BUREAU OF PLANNING AND ZONING

RE: **(26-004 LD&S) – 26020009 – 1400 EAST 4TH STREET (Eastern Gateway aka Gateway on 4th) – LAND DEVELOPMENT AND SUBDIVISION PLAN (LOT CONSOLIDATION AND RE-SUBDIVISION) – Ward 17, Zoned CL, plans dated February 20, 2026.**

The above-referenced plan has been reviewed by the appropriate City offices. We offer the following comments:

Turning Performance Analysis

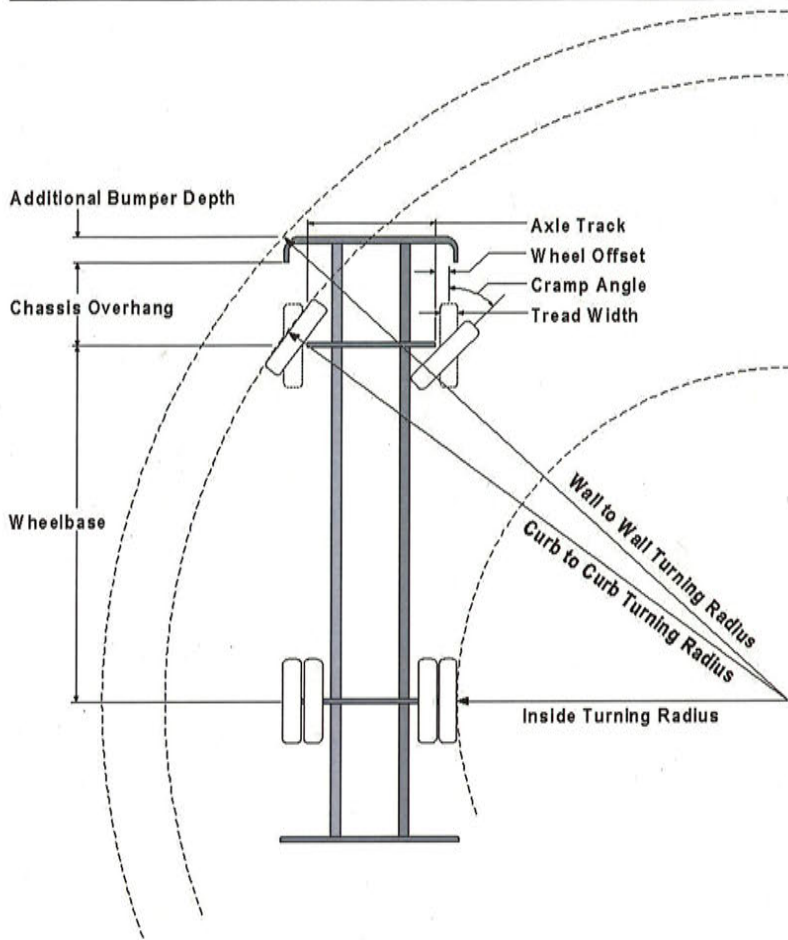
1. The architect/engineer shall confirm fire department apparatus has the required turning space to access all areas (Contact the Fire Department for turning radius information for fire apparatus). Submit a turning plan drawing using the attached data.

13. The following drawings are required to be submitted for Fire Department Review of Land Development Plans:
 - a. Turning Plan using data provided.
 - b. Ladder Reach diagram using data provided.
